# Technical Service Bulletin

**MODEL(S) T7 AMR Autonomous Rider Scrubber**
**AFFECTED:** Models manufactured before serial number 10981578 (April 3, 2020)

**SUBJECT:** Off-board charger interlock switch failure (i.e. damaged or loss of adjustment). The failure may occur if the charger connector is roughly connected or disconnected to and from machine. Switch failure will prevent machine from powering up.

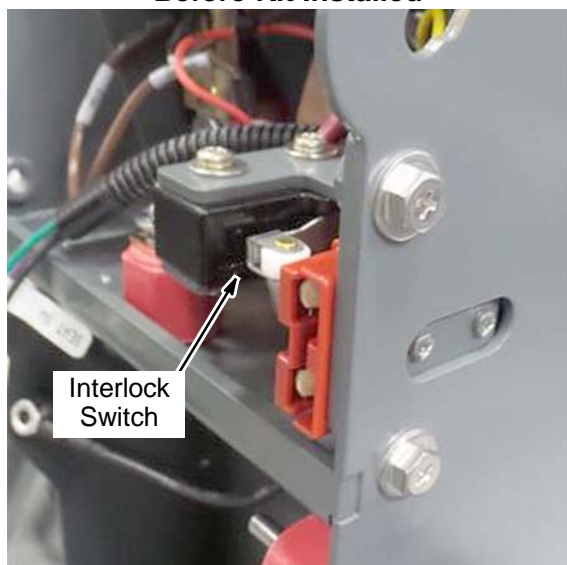
**PURPOSE:** To prevent potential interlock switch failure, install Replacement Switch Kit 9020923. The kit includes a guide connector bracket to protect switch from failure as shown below.
